DECISION OF THE PLANNING COMMISSION

**CLASS 3 DESIGN REVIEW, CLASS 3 SITE PLAN REVIEW, CLASS 2 ZONING
ADJUSTMENT, CLASS 2 DRIVEWAY APPROACH PERMIT CASE NO. DR-SPR-ADJ-
DAP19-11**

SUMMARY: Proposed development of a new 246-unit multiple-family residential apartment complex.

LOCATION: 2575 Center St NE

LANDSCAPE PLAN

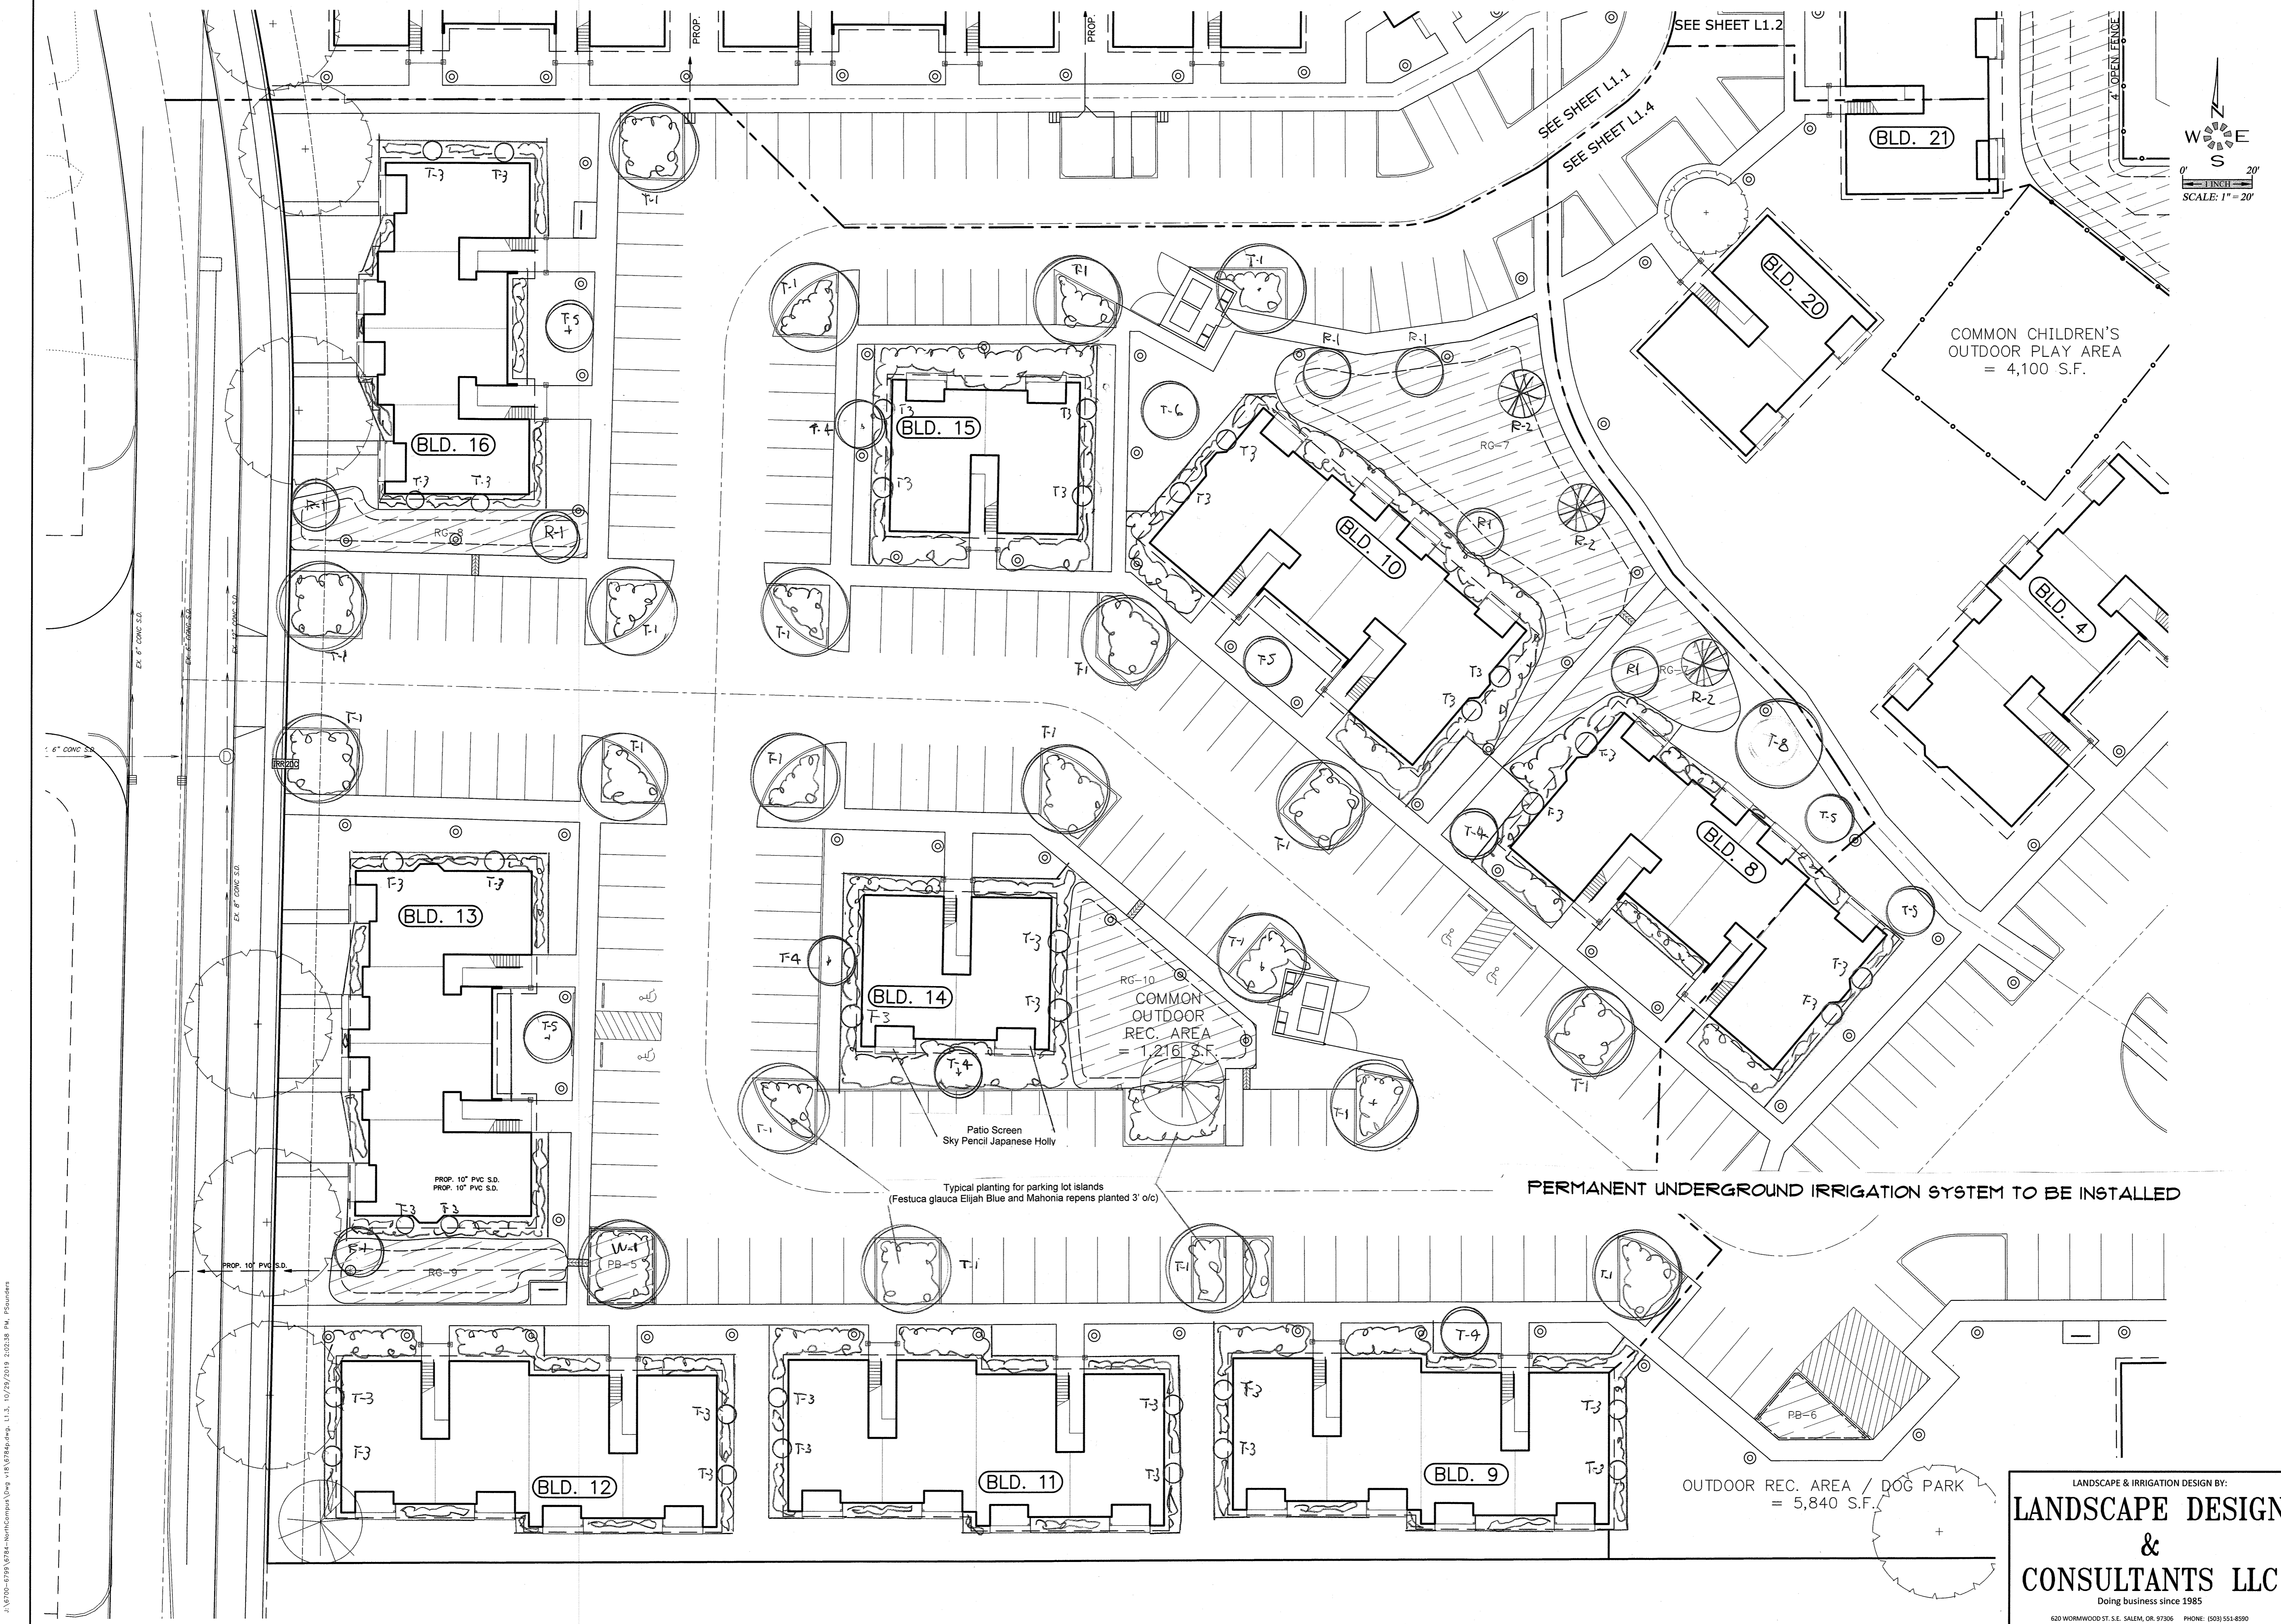
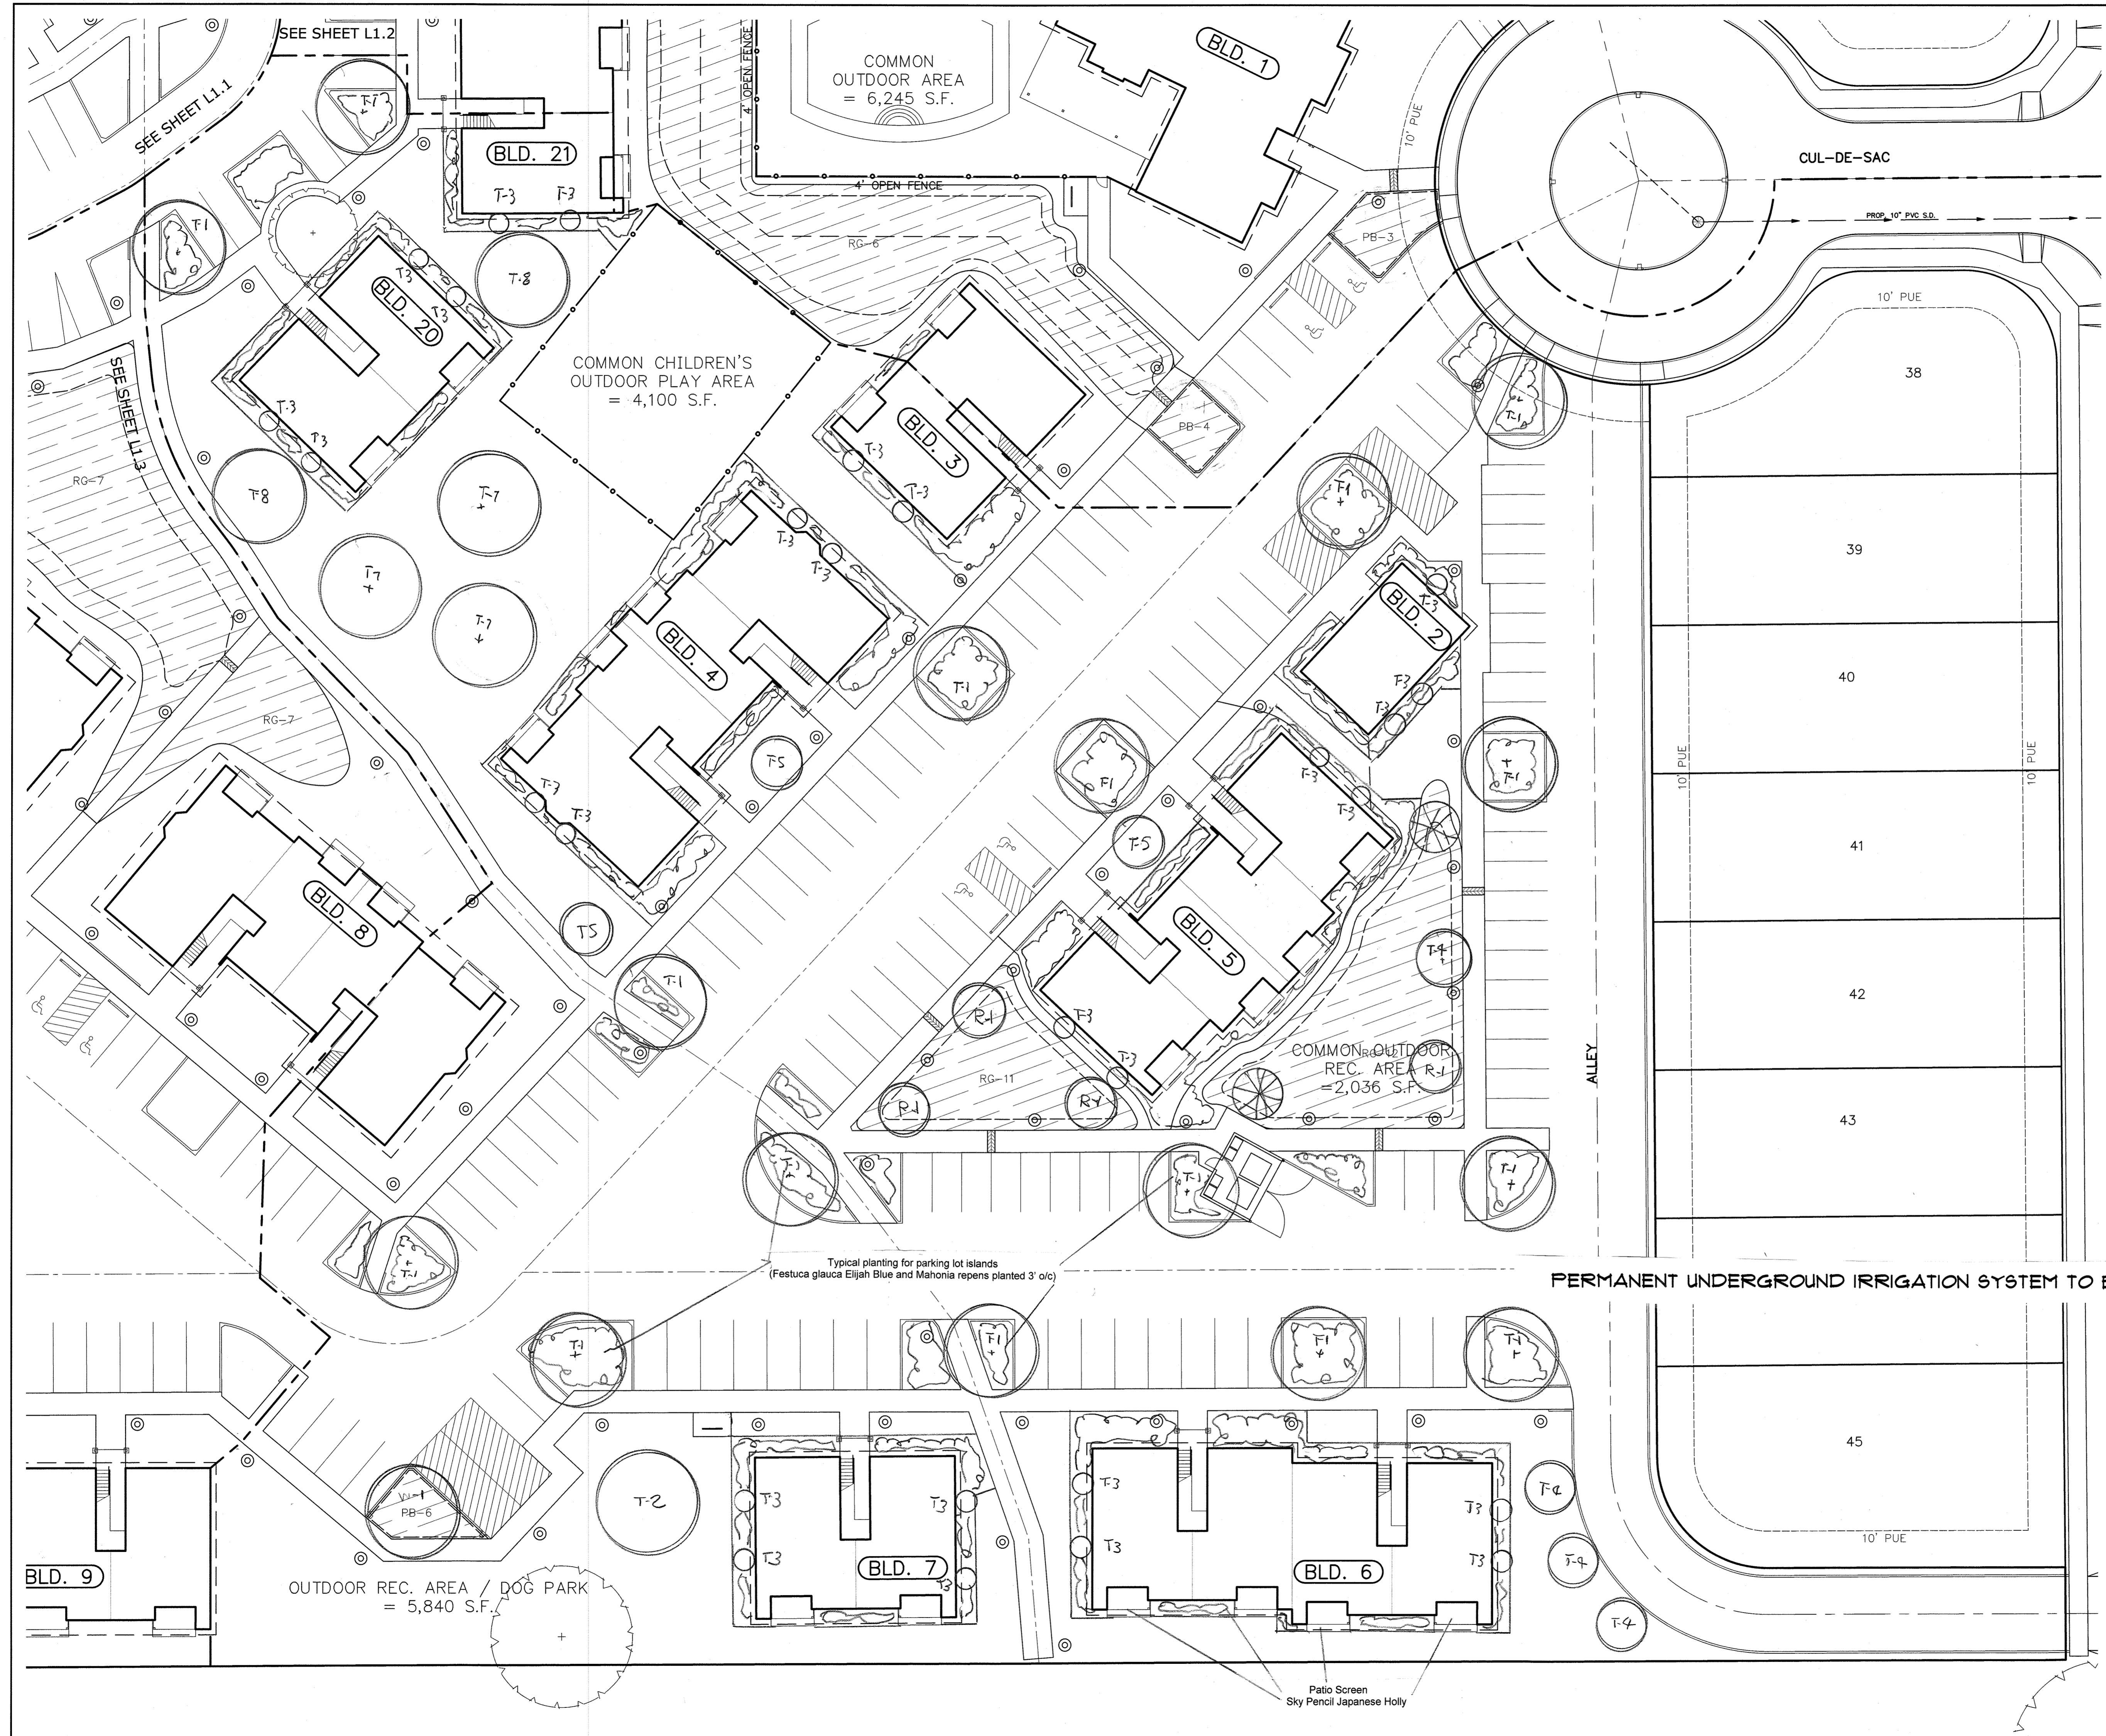
Finding: The corresponding design standard requires a minimum of one tree to be planted for every 2,000 square feet of gross floor area. The subject property is approximately 517,026 square feet in size, requiring a minimum of 259 trees ($517,026 / 2,000 = 258.5$). The preliminary landscape plan indicates that 239 trees will be provided on the subject property, and additional trees will be planted in the public right-of-way, which is not consistent with the design standards.

Condition 1: A minimum of 259 trees shall be incorporated into the landscape design, not including street trees planted in the public right-of-way.
